Responses to Comments
Public Review of Merrimack Station
NPDES Permit No. NH0001465

U.S. Environmental Protection Agency
5 Post Office Square
Boston, Massachusetts 02109

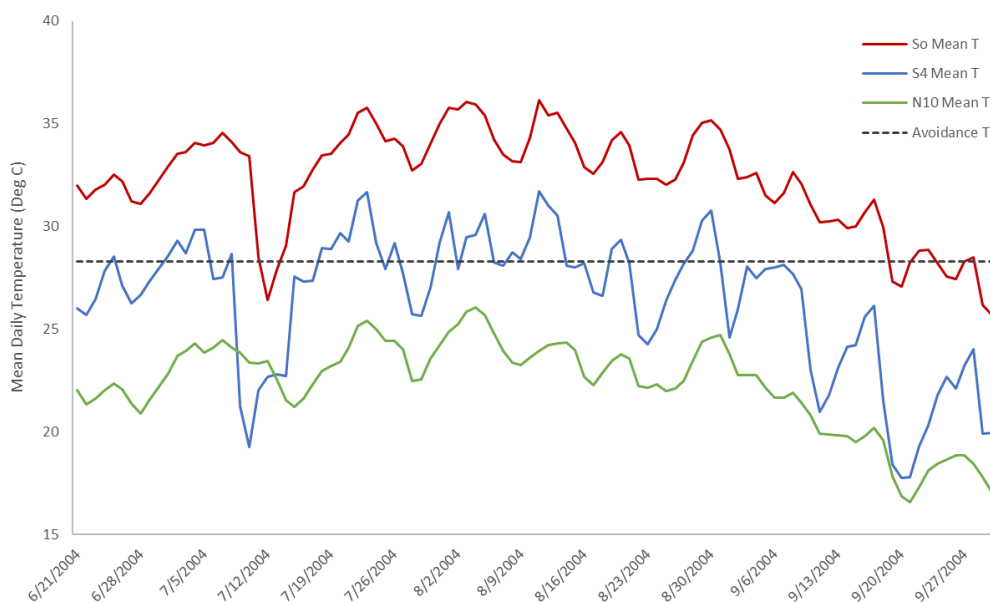
PSNH comments that EPA’s misinterpretation of Normandeau’s 2007 Thermal Model Report is a cornerstone of the Agency’s entire § 316(a) analysis and, as a result, the assertions and/or conclusions of the analysis are called into question. PSNH also provides a “representative sample of instances” from the 2011 Draft Determinations Document where erroneous conclusions were based on this misinterpretation of data.

EPA acknowledges that the temperature data at issue was an integral part of its analysis of the Facility’s thermal impacts in the 2011 Determinations Document and, therefore, a key factor in its proposed decision to reject PSNH’s requested variance under CWA § 316(a). (As PSNH’s consultants have acknowledged, though it is not mentioned in the above comment, EPA’s misinterpretation of the data resulted from the misleading or unclear way in which it was presented by the Facility.) EPA’s misinterpretation of temperature data (due to a lack of clarity in presentation) does not, however, necessarily support either that PSNH’s proposed § 316(a) variance should be granted or that the BIP will be protected. Instead, it supports a re-examination of the in-stream temperature data and the potential of the Facility’s thermal discharge to impact

Figure II.2. Mean and maximum daily (24-hour average) temperature (deg C) at Stations S0 (discharge) and S4 (downstream) from August 10 through September 30, 2010 compared to the juvenile alewife avoidance temperature (28.9°C).

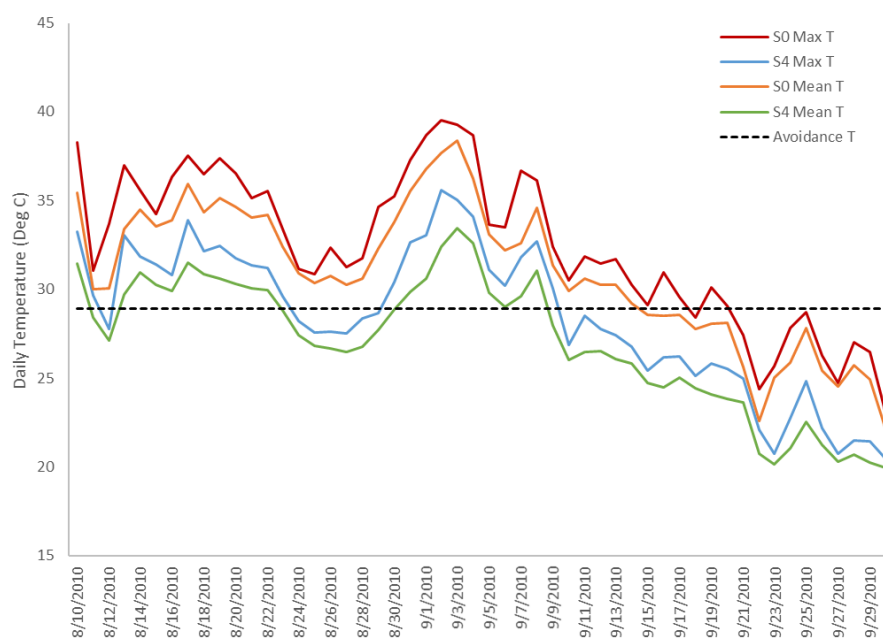
Based on the 2016 averaged data summary, LWB states that the average maximum temperature only exceeded 28.9°C on 14 days between July 16 and August 10, which is before juvenile alewife would be migrating. *See* AR-1300 p. 35, AR-1299. LWB and PSNH conclude that temperatures will be protective during the period in which alewives would be migrating past Merrimack Station. *See id.* EPA reviewed *daily* temperature data over the period from 2004 through 2018. The maximum daily temperature at Station S0 and S4 frequently exceeds 28.9°C after August 10 through early September, including as late as September 22 (at Station S4) and September 28 (at Station S0). Daily data from 2010 demonstrate that the mean daily temperature at S4 during that year was above 28.9°C from August 13 through August 22 and again from August 31 through September 9, and that the maximum daily temperature exceeded 28.9°C for nearly the entire period from August 10 through September 9 (Figure II.2, below). The daily data demonstrates that, in contrast to the LWB's analysis and consistent with EPA's conclusion in the 2011 Draft Determinations Document, temperatures in the river are above the protective temperature during the period when outmigrating juvenile alewife are present.

At the same time, EPA acknowledges that juvenile alewives could potentially avoid higher temperatures if the plume were sufficiently limited to allow areas of passage. The 2016 data demonstrate that the average daily temperature at Station S0 is less than the avoidance temperature of 28.9°C (84°F) on each day beginning on September 5, which indicates that river temperatures at S0 appear to be suitable for juvenile alewives by the end of the first week of September. When operating as a baseload plant, such as in 2010, the sustained, elevated temperatures could potentially exclude juvenile alewife from habitat downstream of the Merrimack Station for sustained periods, including when juveniles are outmigrating and must

Figure II.4. Mean and maximum daily (24-hour average) temperature (deg C) at Station S4 (downstream) from June 25 through September 3, 2018 compared to the acute protective temperature for juvenile American shad (29.4°C).

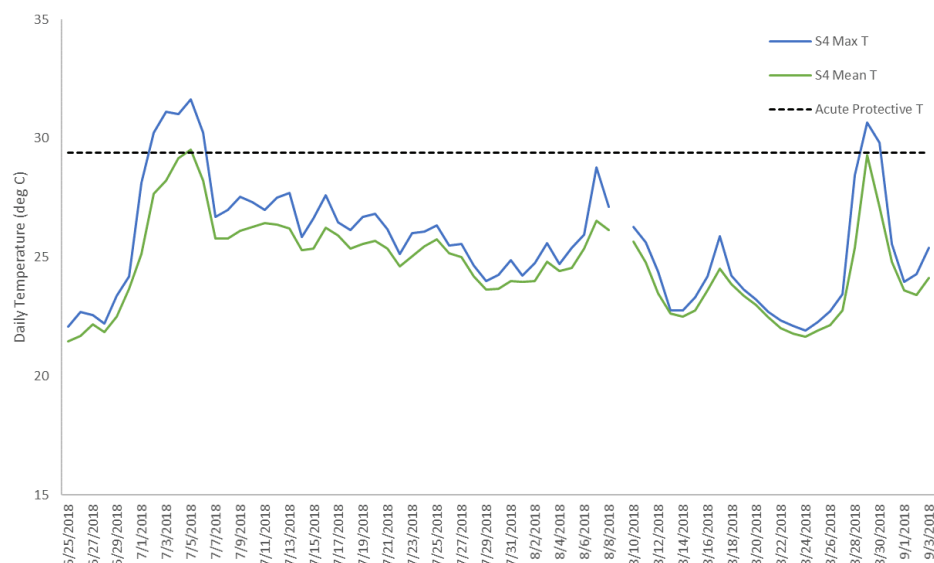
Normandeau also comments that, based on the mean average daily temperature (rather than just the maximum), Station S0 did not reach the lethal temperature identified for larval American shad (33.3°C) at all in June and only on 10 dates in July, and that the mean average daily temperature at Station S4 is well below the lethal temperature for all dates in June and July. *See* AR-872 pp. 98-9. Yet, EPA's review of daily temperature data from 2004 through 2018 indicates that the mean, maximum, and minimum S0 temperatures reach or exceed 33.3°C in July, when Merrimack Station is operating, in some cases for 25 days or more (e.g., 2004, 2007, 2010, 2011). The mean daily temperature at Station S4, however, is typically below lethal temperatures, though mean temperatures did reach or exceed 33.3°C on 8 days in 2010. In addition, the maximum S0 temperature has rarely reached 33.3°C at Station S0 since 2014, and S4 temperatures have not reached lethal temperatures since 2010.

While EPA overestimated the duration that the maximum temperature at S4 exceeded certain thresholds (due to a misunderstanding of the data), PSNH, Normandeau, and LWB, by relying only on long-term average data, plainly underestimate the severity and duration of exceedances of the protective temperature for juvenile and larval American shad due to the thermal plume during the period when they are likely present in the Merrimack River. Again, however, the potential impacts of the thermal plume on American shad have changed substantially since Merrimack Station transitioned to reduced operations like that of a peaking plant. As an example, Figure II.4 presents the mean and maximum daily temperature at Station S4 in 2018, which is representative of average operation in August and September and includes 6 dates in July when exceeded protective temperatures for larval American shad at Station S0. Under current operations, temperatures at Station S4 rarely reached or exceeded protective temperatures for juvenile American shad and exceedances that did occur were limited in duration. EPA concludes that the thermal plume under current operations is unlikely to impact juvenile American shad because juveniles are likely to avoid the plume for the limited period when it is present downstream of the discharge and will not be excluded from potentially suitable habitat for extended periods of time. EPA has also determined, in response to this and other comments received, that acute mortality is not likely to occur as a result of exposure to the thermal plume because, as just noted, American shad juveniles are mobile, will likely avoid extreme temperatures that may occur in the relatively limited segment from S0 to S4, and because under current operations it is uncommon for river temperature to exceed the acutely lethal temperature. In addition, an acute mortality limit at Station S4 will ensure that conditions in the river are protective of American shad larvae and will not result in acute mortality. *See* Response to Comment II.3.4.7.

Figure 1: Merrimack Quarterly Heat Input, 1995-Present²¹

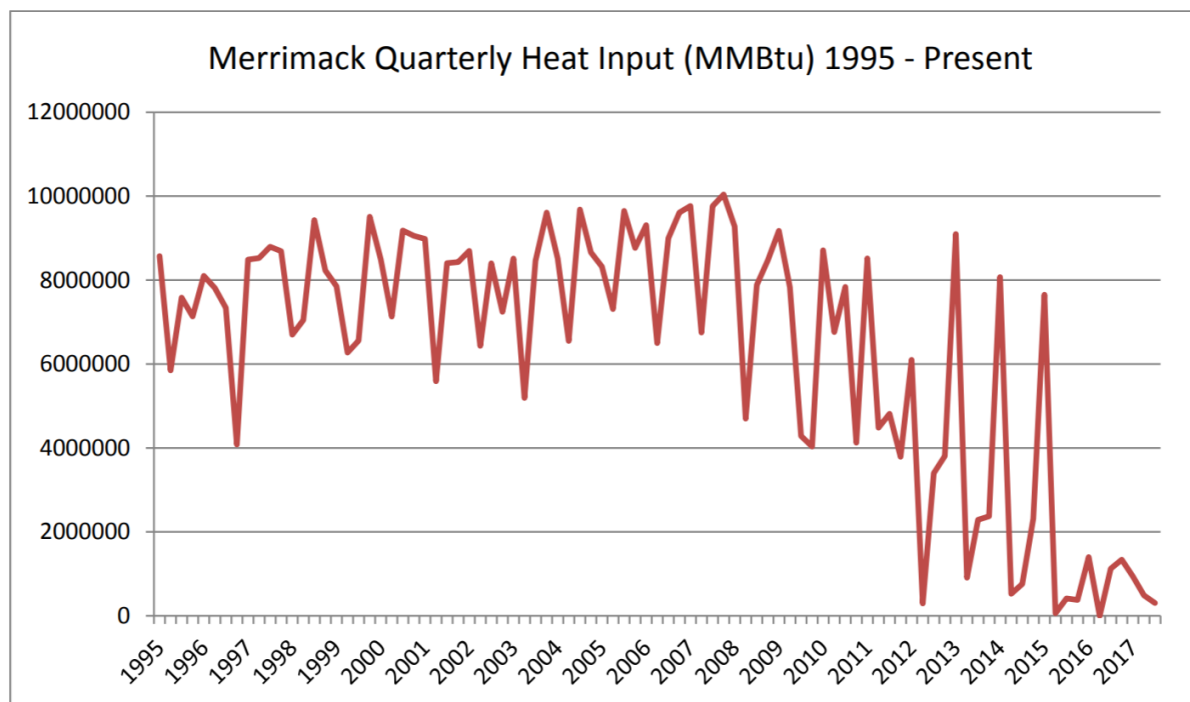
Second, as EPA implicitly recognizes, while Merrimack’s annual capacity factor may be lower in recent years than in years further back, it still operates quite heavily for short periods of time in the winter and in the summer. Setting limits based on annual output would improperly ignore Merrimack’s high level of operations, and concomitant environmental impacts, during those periods of time. This would be particularly troublesome given the seasonality of the thermal impacts described above, where it is precisely the thermal pollution Merrimack causes during the winter that provides a toehold for invasive species and threatens the balanced indigenous population of aquatic species in the Merrimack river.

Third, the unfortunate fact is that EPA is extremely slow in issuing NPDES permits for large facilities in New Hampshire, and for Merrimack in particular. These comments are submitted as part of the third round of comments solicited by EPA on this one permit, in a process that started over five years ago. Indeed, Merrimack has been operating under a permit that expired two decades ago, and was issued a quarter-century ago. Although Commenters certainly hope that EPA will finalize this permit soon, and will thereafter hew to the five-year permit review cycle mandated by Congress, the history of this permit and this plant raises the possibility that whatever permit EPA does finalize for Merrimack may govern the plant’s operation for many years to come. Just as Merrimack’s operation has changed considerably in the past, it is possible that it will vary considerably in the future.

Figure 3-1. Trends in electrical generation by season at the Merrimack Station, 2007 - 2016.

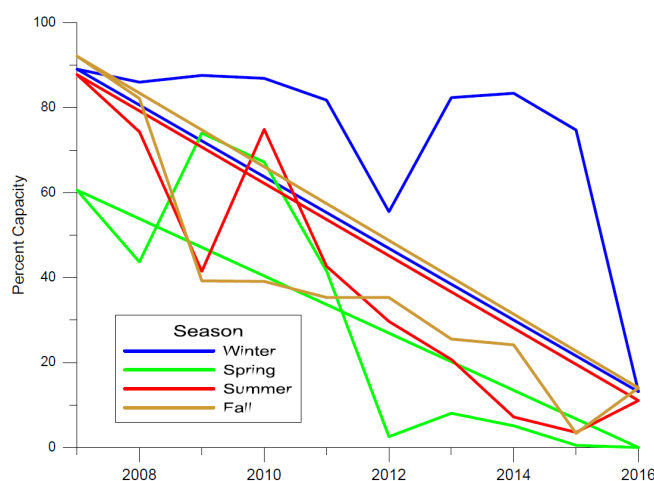
First, the potential thermal exposures should reflect likely operation of the Merrimack Station over the upcoming NPDES permit period (typically five years). As clearly demonstrated in ISO New England (2017), the Station no longer operates as a base-loaded facility as it had prior to

2010. Hence, temperature monitoring data collected prior to the draft NPDES permit (2011) does not reflect current conditions. The Merrimack Station operates principally as a peaking facility operating only when economic dispatch requires. A re-graphing of the generation data provided in ISO New England (2017) reveals a distinct seasonal pattern in operation (Figure 1). This graph clearly illustrates a substantial decline in the electrical generation at Merrimack since 2007 throughout the year except during winter. Hence, the magnitude and extent of thermal exposures to the aquatic community during most of the year are likely to be much lower than when Merrimack was operating as a baseload facility. During spring and summer, when biological productivity and potential for thermal stress is highest, Merrimack is typically operating at a capacity factor of less than 20 percent. That is only a small fraction of generating capacity of this facility prior to the 2011 draft NPDES permit. Only during winter, when natural gas availability constraints limit operation at other generating facilities is Merrimack called to run often. However, biological stresses from elevated temperatures at this time of the year should be minimal owing to low river water temperatures.

Figure - *Corbicula Fluminea* in the United States

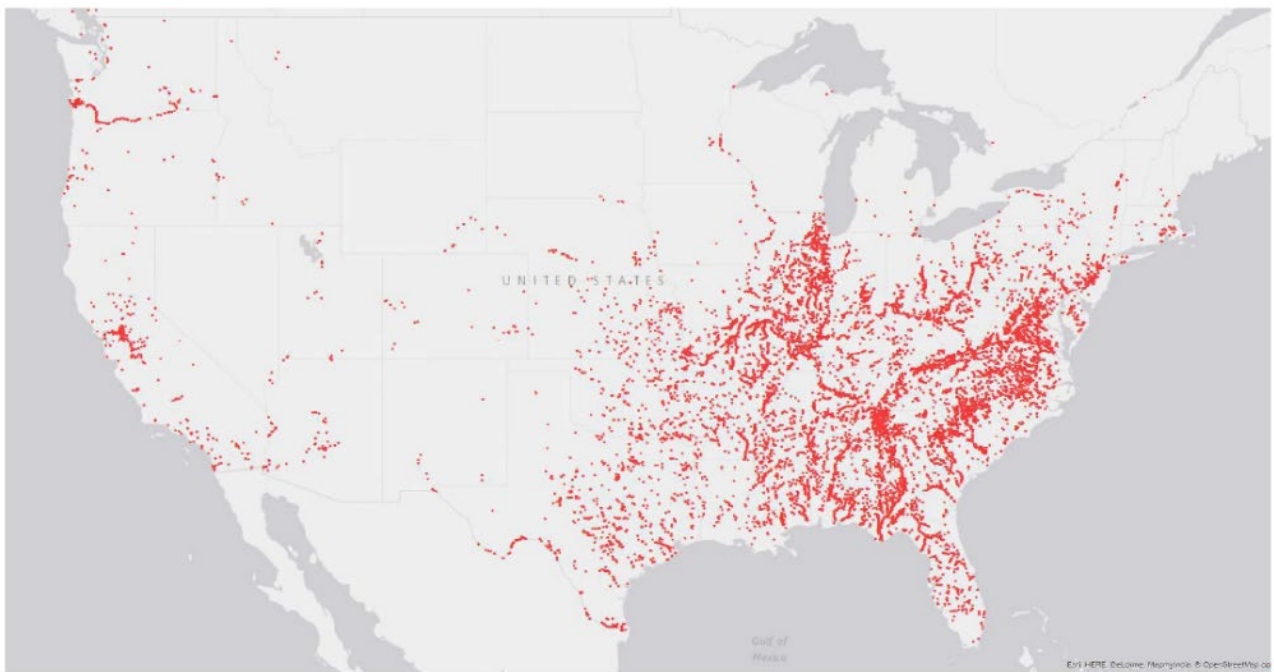
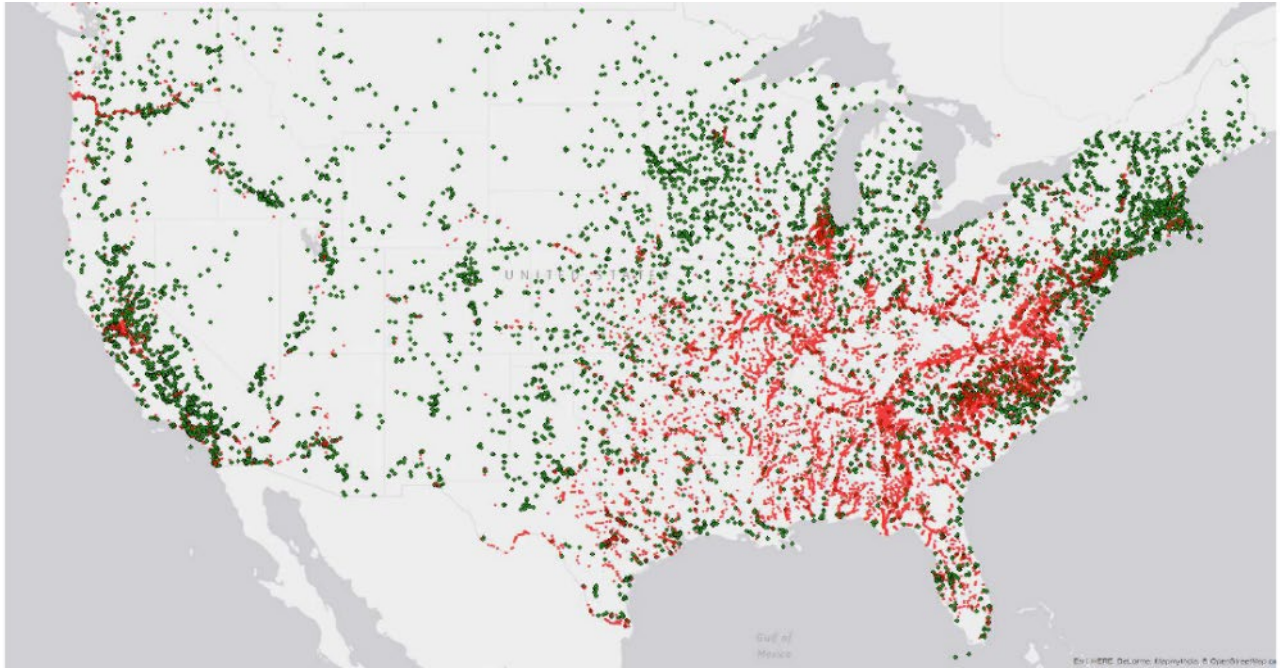
The Asian clam is ubiquitous, as the Statement notes,²⁸¹ and found throughout the United States near power plants and elsewhere. Asian clams are prolific up major waterways in the west (e.g., Columbia River, Sacramento Delta region), up the Mississippi and Ohio Rivers and their watersheds, and along the east coast in major harbors, rivers, and their various tributaries. The figure below shows the extent of the Asian clam's presence in the United States:

The red dots shown on the map represent Asian clam locations reported in the United States Geological Survey (USGS) database.²⁸² Further, the Asian clam is extensively found near power plants (shown in green):

Figure 4-1. Percent withdrawal versus total number entrained during Merrimack River entrainment studies (2006-2007) (Normandeau 2007b).

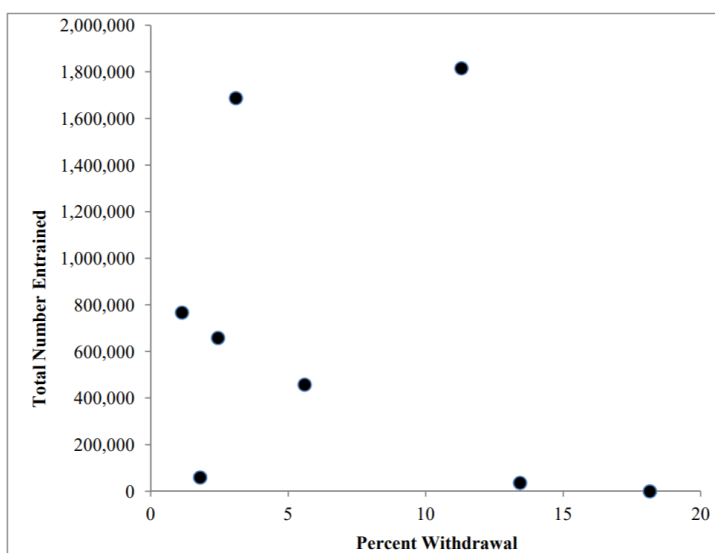
[Responding to AR-618, p. 245 Section 11.2.1a] USEPA provides no evidence for the assertion that eggs and larvae are equally distributed throughout the river. In fact, the peer-reviewed scientific literature indicates that ichthyoplankton have a very patchy spatial and temporal distribution. USEPA provides no basis for its assumption that the percent of water withdrawn for cooling can provide an estimate of the percentage of the ichthyoplankton lost to entrainment. The percentage of the water withdrawn is a factor in determining entrainment, but density of ichthyoplankton in Hooksett Pool over space and time are also important factors. Existing entrainment and withdrawal data do not support the Agency's assumption that entrainment is proportional to percent water withdrawal because the months with the greatest percentage withdrawal are also the months with the lowest ichthyoplankton densities. Figure 4-1 presents a plot of percent withdrawal on the x axis versus total entrainment on the y axis (Table 3-7; Normandeau 2007b). There is no apparent positive relationship between percent withdrawal and total monthly entrainment. In fact, a non-parametric Spearman Rank Correlation analysis indicates that there is a negative relationship (-0.41) between percent withdrawal and total monthly entrainment. The raw data are presented in Table 4-1. The months with the greatest percent withdrawal, August and September 2006, also have the lowest entrainment because ichthyoplankton are not common in Hooksett Pool during those months. The highest entrainment occurred in June of 2006 and 2007 when percent withdrawal was relatively low (June 2006), or

above average (June 2007) but entrainment was highest due to the high density of ichthyoplankton in Hooksett Pool. The conclusion to be drawn from this analysis of empirical data is that percent water withdrawal alone is not a major factor in determining entrainment at Merrimack Station. Density of ichthyoplankton in Hooksett Pool is also an important factor and the greatest percent withdrawals occur in the months when ichthyoplankton density is low. It can be seen that during May, low ichthyoplankton densities are the norm, and that the entrainment estimate for May at Unit 2 is driven by the relatively large amount of ichthyoplankton collected on the night of 31 May (Table 4-2). The data from the night of 31 May might be considered the outlier rather than the 0 counts at Unit 1, but Normandeau included all data in the analysis because there are no methodological reasons to exclude them. Empirical data should not be excluded because it appears to be “different,” but may only be excluded if there is some methodological reason that would justify the exclusion, such as abnormal field sample collection or mishap during laboratory analysis. These incidents did not occur. Therefore, USEPA’s rationale for excluding the data for Unit 1 from May, and substituting the Unit 2 data for the Unit 1 data is not valid. Normandeau’s data estimated 3.2 million larvae per year were entrained, and USEPA improperly changed this number to 3.8 million larvae entrained.
